## RYKER 2019-020-021-022 Gearbox improved Parts - 140638

This TST includes solution for the noise that can be heard or felt under deceleration at high speed.

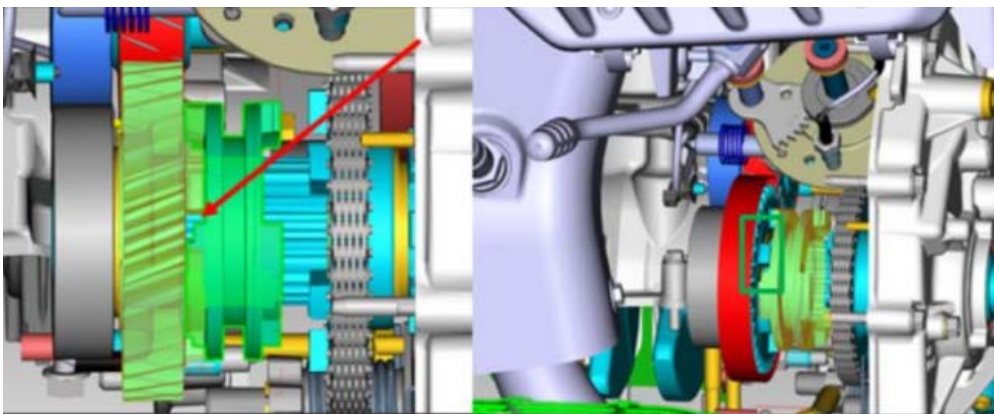
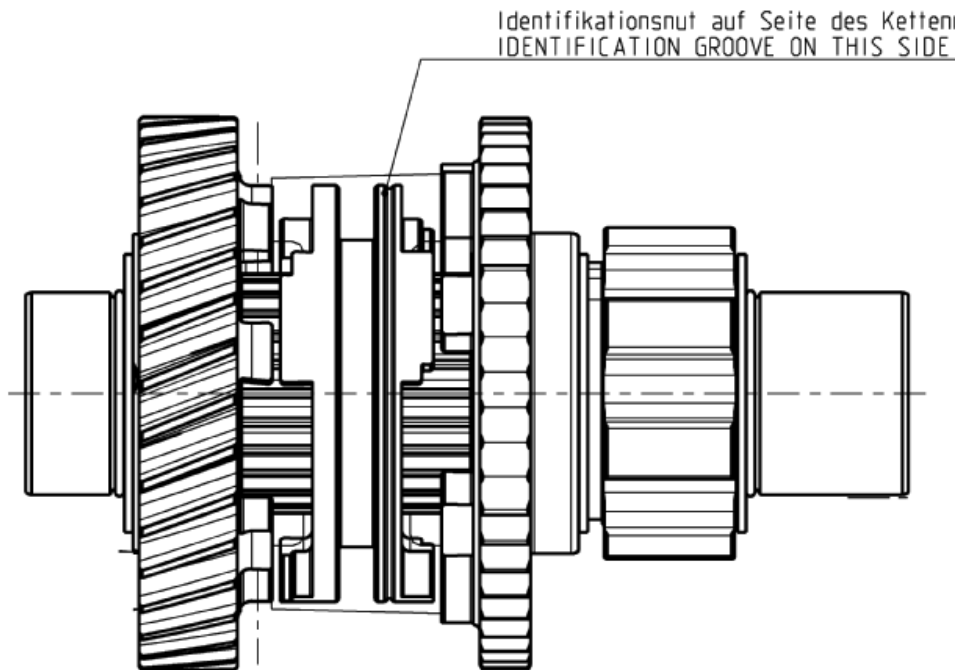
The gearbox is making a loud noise when releasing the throttle at +/- 80 km/h (50 mph). The problem is from the gearbox's internal parts (shifting sleeve & FWD gear).

Addition of a 5 degrees undercut angle to the steps on the shifting sleeve and forward gear. This improvement avoids gear-to-sleeve skipping under deceleration at higher speed. Addition of a 5 degrees undercut angle to the steps on the shifting sleeve and forward gear. This improvement avoids gear-to-sleeve skipping under deceleration at higher speed. MY23 Ryker gearboxes are built with these improvements.
